Project	IEEE 802.16 Broadband Wireless Access Working Group http://ieee802.org/16 >		
Title	Corrections for AAS Diversity-Map Scan in OFDMA PHY		
Date Submitted	2004-11-1		
Source(s)	Tal Kaitz, Ran Yaniv Alvarion tal.kaitz@alvarion.com, ran.yaniv@alvarion.com		
	Dave Pechner, Todd ArrayComm Inc. dpechner@arraycomm.com, dahlby@arraycomm.com, chauvin , Doug Dahlby, Adam Kerr dpechner@arraycomm.com, chauvin@arraycomm.com		
Re:	IEEE P802.16-REVd/D5		
Abstract	This contribution introduces corrections for support of AAS Diversity-Map Scan in the OFDMA PHY		
Purpose	Adopt into P802.16d/D5 corrigenda		
Notice	This document has been prepared to assist IEEE 802.16. It is offered as a basis for discussion and is not binding on the contributing individual(s) or organization(s). The material in this document is subject to change in form and content after further study. The contributor(s) reserve(s) the right to add, amend or withdraw material contained herein.

Corrections for AAS Diversity-Map Scan in OFDMA PHY

Dave Pechner, Todd Chauvin, Doug Dahlby

[Replace figure 224 with the following]

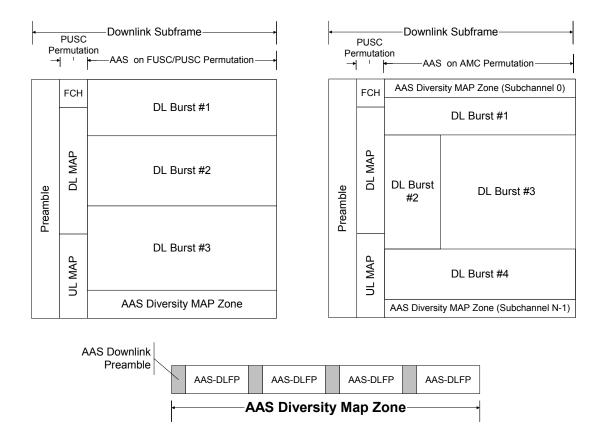
The AAS DL Zone begins on the specified symbol boundary and consists of all subchannels for the specified duration of the Zone. The two highest numbered subchannels of the AAS DL Zone may be dedicated at the discretion of the BS for the AAS Diversity-Map Zone in the PUSC, FUSC and optional FUSC permutation. For the PUSC permutation, it is assumed that all AAS subscribers can decode the FCH in order to know the Used Subchannel Bitmap. In the AMC permutation, the 4th and (N-4)th first and last subchannels of the total N subchannels of the AAS DL Zone may be dedicated at the discretion of the BS for the AAS Diversity-Map Zone. For AMC permutation, each subchannel for the AAS diversity MAP consists of 3 bins by 2 symbols. When these subchannels are used for this purpose, they shall not be allocated in the normal DL-MAP message and shall be used only on the AAS portion of the DL sub frame. These sub-channels will be used to transmit the AAS-DLFP() whose physical construction is shown in Figure 223.

The purpose of the AAS Diversity-Map Zone is to provide a robust transmission of the required base station parameters to enable SS initial ranging, as well as SS paging and access allocation. This is achieved through transmitting the AAS-DLFP message using a highly robust form of modulation and coding (namely QPSK-1/2 rate with 2 repetitions). The start of an AAS-DLFP is marked by an AAS DL preamble. The AAS-DLFPs transmitted within the AAS Diversity Map Zone may, but need not, carry the same information. Different beams may be used within the AAS Diversity Map Zone, however each AAS Downlink Preamble and associated AAS-DLFP must be transmitted on the same beam.

The UL and DL AAS Zones are defined by the uplink and downlink extended AAS-IE in the broadcast map. In the case that a SS cannot hear the broadcast maps, the SS will scan for the DLFP messages and utilize private maps within the AAS zone.

It is assumed that all AAS subscribers will be able to determine the IDcell used in the selection of the DL preamble at the beginning of the DL frame. The same IDcell shall be used as the DL_PermBase of the first zone in the AAS portion of the DL subframe. The UL_PermBase for the UL zone referred to by the initial ranging allocation in the AAS-DLFP shall be that provided in the UCD message. For AAS subscribers that cannot detect the AAS_DL_IE transmitted in the DL-MAP which specifies the boundaries and permutation of the AAS DL Zone, they must search over the possible permutations (PUSC/FUSC/AMC) and starting symbol to detect the AAS-DLFP. The permutation for the AAS UL Zone is specified by a field in the AAS-DLFP.
